**SERVICE
BULLETIN**

MANDATORY BULLETIN Z 242L/29a, Z 143L/16a

3. **SUBJECT:** Occurrence of the checking block L 143.8521 damage in operation.
4. **CORRECTION:**
 - 4.1 Repair of the block - removal of the cooler eloxal coating and/or replacement of defective transistors in the checking block, if necessary.

Fig.: Checking block L 143.8521

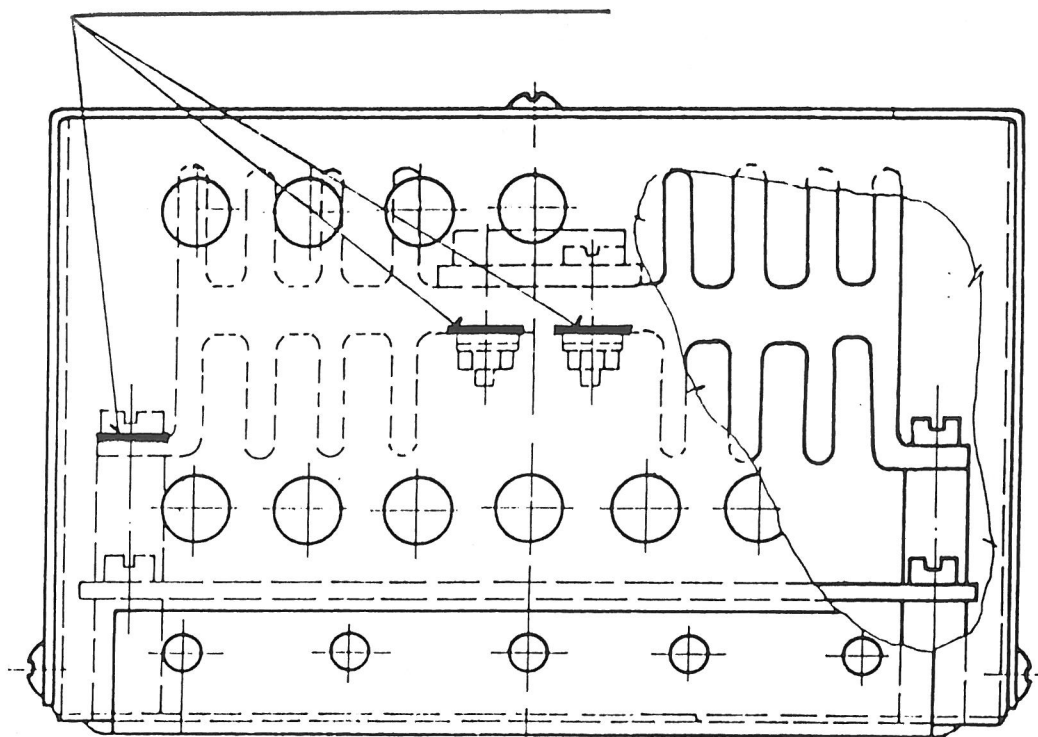
- 9.3 Removal of the failure cause:
Remove the eloxal coat layer of the cooler under attachment nuts of all three KD 503 transistors (or their equivalents) and under the screw of the supply voltage lead to the cooler. After cleaning off and tightening, re-paint these joints with the protective lacquer.

REMOVE THE ELOXAL COAT LAYER
